Access Compliance Report

Public Rights-of-Way

(Curb Ramps)

Intersection ID: N/A	Main Street: E_3RD_ST	Cross Street: S_COLLEGE_ST	Location: N
ADA ID: FB589AEA29AC	Ramp Type: PerpDiag	Initial Pass/Fail: Fail	Overall Compliance: No
		Severity Score: 25

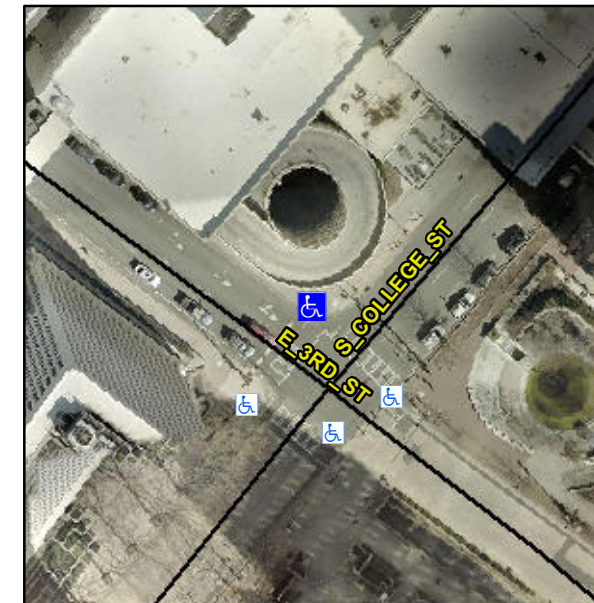
Not Found, R304.2.2, R304.5.3

Compliance	Description	Data	Compliance	Description	Data
N/A	Ramp Length (in)	61.0	No	Ramp Slope (%)	9.1
Yes	Ramp Width (in)	48.0	No	Ramp XSlope (%)	5.6
N/A	Flare Type LT	N/A	N/A	Flare Type RT	N/A
N/A	Flare Slope LT (%)	N/A	N/A	Flare Slope RT (%)	N/A
N/A	Flare Traversable LT?	N/A	N/A	Flare Traversable RT?	N/A
N/A	Landing Length (in)	N/A	N/A	DWS Provided?	N/A
N/A	Landing Width (in)	N/A	N/A	DWS Contrast?	N/A
N/A	Landing Slope (%)	N/A	N/A	DWS Length (in)	N/A
N/A	Landing X Slope (%)	N/A	N/A	DWS Full Width?	N/A
N/A	Landing Curb? (Y/N)	N/A	N/A	DWS Offset (in)	N/A
N/A	Shared Landing?	N/A			
N/A	Gutter Ponding?	N/A	N/A	Gutter Slope (%)	N/A
N/A	Gutter Lip Ht (in)	N/A	N/A	Gutter X Slope (%)	N/A
N/A	Painted X Walk1?	Yes	N/A	Painted X Walk2?	Yes
	X Walk 1 Direction	To SW		X Walk 2 Direction	To SE
N/A	X Walk 1 Width (in)	107.0	N/A	X Walk 2 Width (in)	107.0
	X Walk 1 Slope (%)	0.8		X Walk 2 Slope (%)	1.9
	X Walk 1 X Slope (%)	0.7		X Walk 2 X Slope (%)	0.4

Remove & Replace Curb Ramp With Two New Directional Ramps or Equivalent.
